## ...TO "READER CIRCUIT"

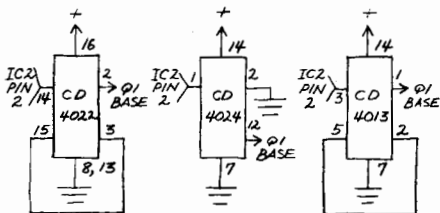
Many thanks for publishing my circuit for the calculation/stopwatch adapter in the April 1977 Solid State column. I note, however, that I omitted the connection from pin 13 of *IC2* to ground. This connection must be made to enable the chip. Also, the debounce circuitry in some calculators apparently does not respond properly to the commands given at the 10-Hz rate. The solution to this is to put another divider into the circuit so that the switch operates at a 5-Hz rate. Some circuits that can be used to accomplish this are shown below. Using these circuits, it may be

necessary to experiment with the value of *C4*, which determines the time the switch remains closed; I found 0.033 μF to work best on one of my slow calculators. With the slower rate, naturally, the calculator should be keyed ., 2, +, but the rest of the operation is the same.
—*Will Hobbs, Eugene, OR*
